**MEMORANDUM**

DATE: April 14, 2011

SUBJECT: Case No. **ZC-11-08: Setdown Report** for a Consolidated Planned Unit Development and Zoning Map Amendment for 2700 16th Street, N.W., filed by Goulston & Storrs on behalf of Il Palazzo LLC

Courts

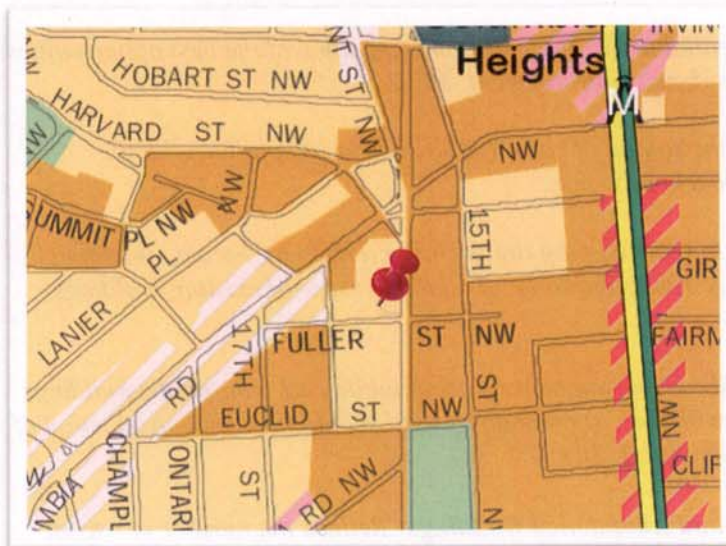
The applicant has expressed that there are several court areas on the plans that would require relief. OP expects the applicant to identify these court areas in its public hearing submission.

The Office of Planning will work with the applicant to further refine and define these requests prior to public hearing, should the Commission set down the application.
